SUBJECT: NuScale Power, LLC Response to NRC Request for Additional Information No. 202 (eRAI No. 8911) on the NuScale Design Certification Application

eRAI No.: 8911

NRC Question No.: 03.09.02-19

Figure 4-7 Fuel core model (with real element shapes) and its connections to LRV

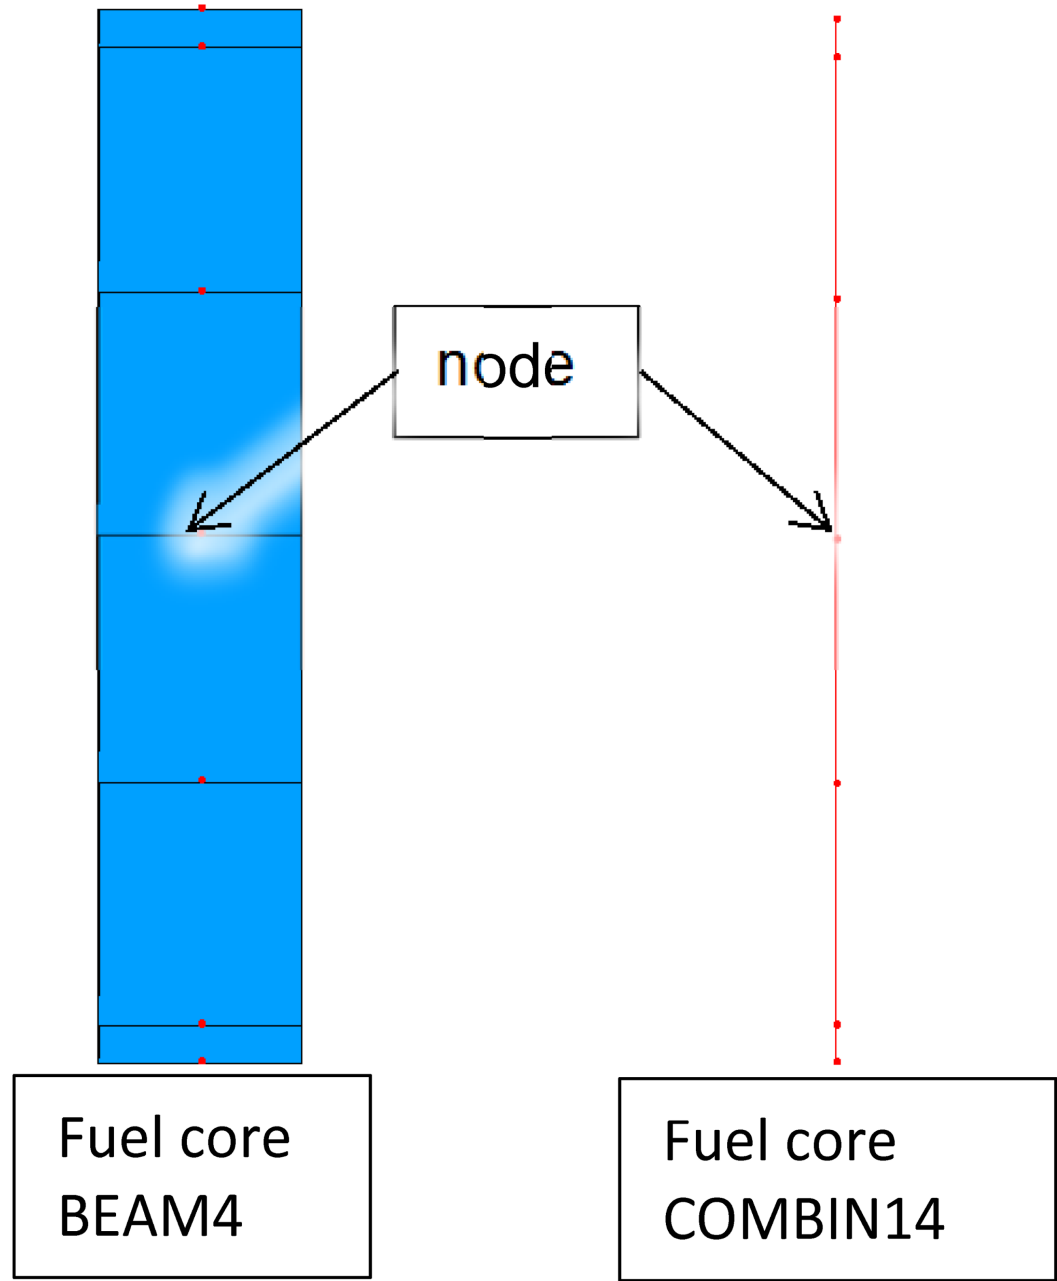
3. Provide a FE mesh figure of the lower RVI model with the fuel assembly model attached and locations of the attachment.
4. Table 4-8 in section 4.1.3.2 depicts fuel beam element properties. Provide the formulas used in the calculations of the lower nozzle spring stiffness, fuel spring stiffness and upper nozzle spring stiffness. Provide key to the abbreviations BN, HMP, HTP1-4, and TN in Table 4-8?

Subquestion 3: The FEM of the fuel core model and its connections to the lower RVI model is shown in Figure 4-7.

The Figure 4-7 has been added to the TR Section 4.1.3.2.

Figure 4-8 Fuel core model elements (real element shapes) and nodes

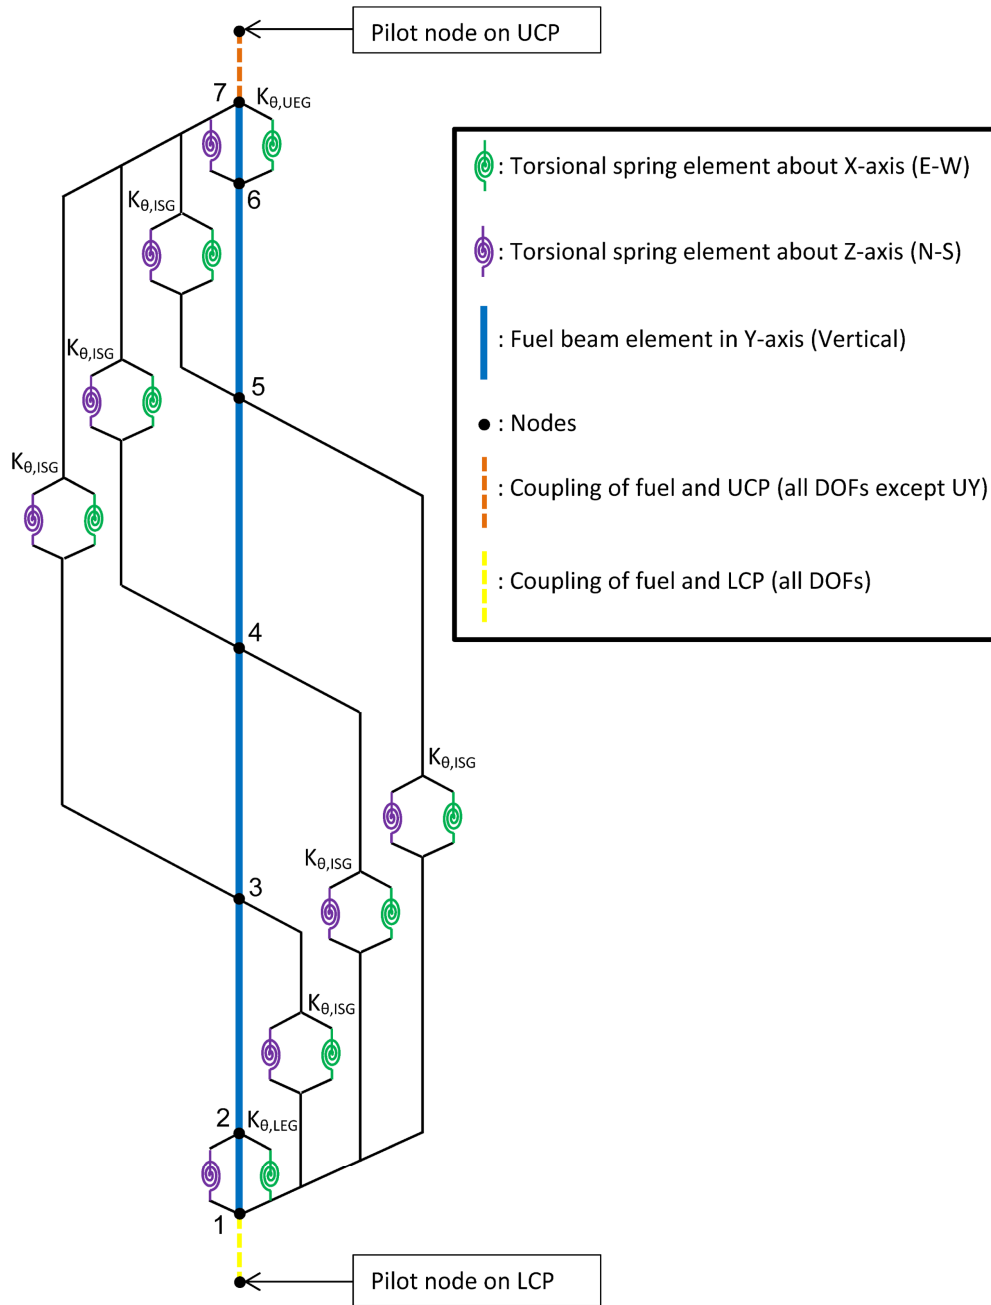
5. Figure 4-6 in section 4.1.3.2 shows a simple sketch of the fuel assembly stick model with rotational springs attached. The applicant is requested to provide a figure of the full fuel assembly FE model with all the beams and spring elements. Also provide a sketch that uses traditional circle type legend to represent the rotational springs. If three rotational springs are needed for coupling in three directions, include all three springs in the sketch and provide detailed explanation of the sketch. The sketch should indicate the components and locations where the fuel assembly model is coupled to.

Subquestion 5: The fuel core FEM beam and spring elements are shown in Figure 4-8. The sketch showing rotational springs is in Figure 4-9. These springs have rotational DOFs about two horizontal directions (X-axis and Z-axis). The beam elements have six DOFs at each node: translations in x, y, and z directions and rotations about the x, y, and z axes. The beam elements are homogenized representations of the entire fuel core cross-section, and have aggregate cross-sectional properties of the fuel rods, guide tubes, and the instrumentation tube. The top and bottom of the fuel are coupled to the upper core plate (UCP) and lower core plate (LCP) respectively, by defining rigid region (CERIG command), to represent top and bottom nozzle assemblies with rigid stiffnesses.

Figure 4-9 in TR-0916-51502 has been updated per this response. Figure 4-8 is added to the TR-0916-51502. The abbreviation for degree of freedom (DOF) has been added to Table 1-2.
